Product Change Notification: CAAN-27VKXJ630

CCB 6849 Final Notice: Qualification of STA as an additional assembly site for selected AT42QT1x, AT42QT21, AT42QT41, ATmega16, ATmega32, ATmega48, ATmega8x, ATtiny26, ATtiny46, ATtiny8x, QT60160 and QT60240 device families available in 32L VQFN (5x5x1mm) package.

CCB 6849
Pre and Post Change Summary
PCN #: CAAN-27VKXJ630

ANAC

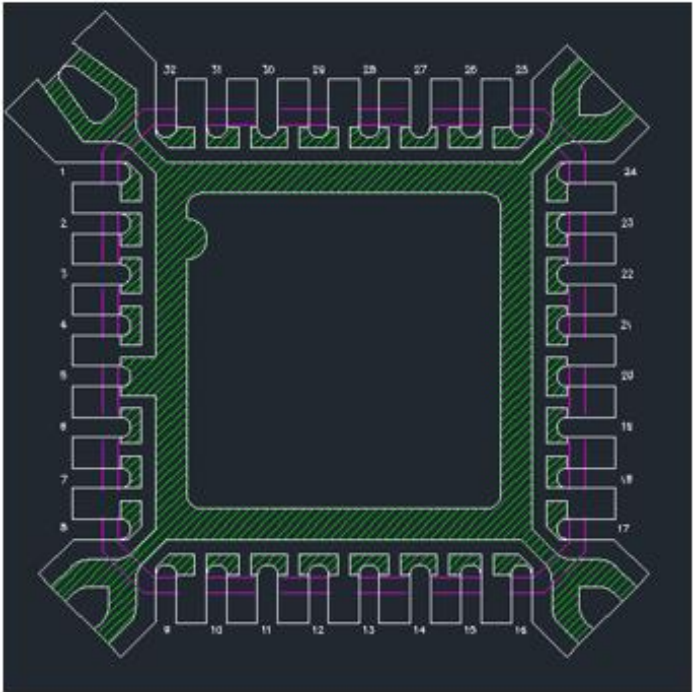
Wire Material	Au	CuPd
Lead-Frame Paddle Size	146X146mils	
Lead-Frame Material	C194	
Lead-Frame Lead Lock	No

STA

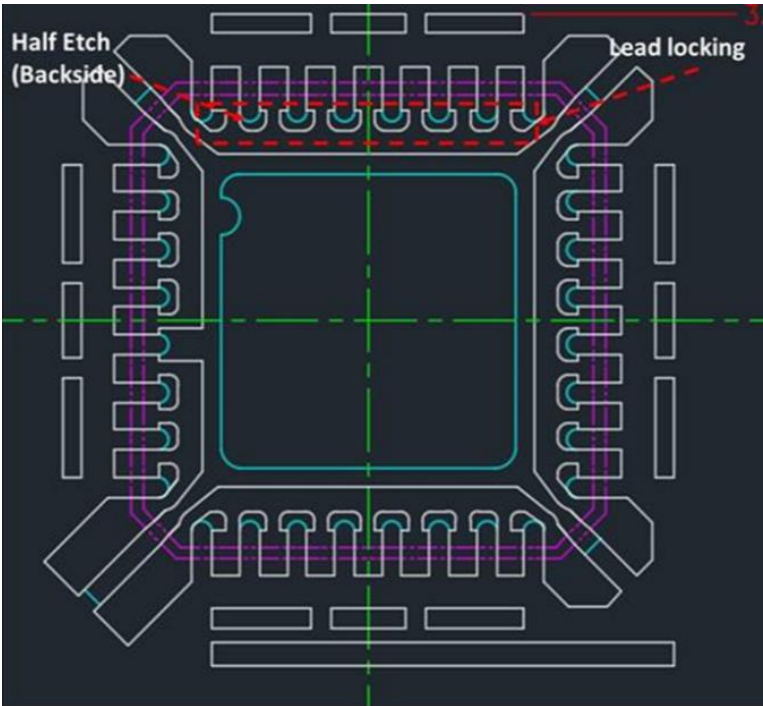
Wire Material	Au	CuPdAu
Lead-Frame Paddle Size	138X138mils	
Lead-Frame Material	C194	
Lead-Frame Lead Lock	Yes
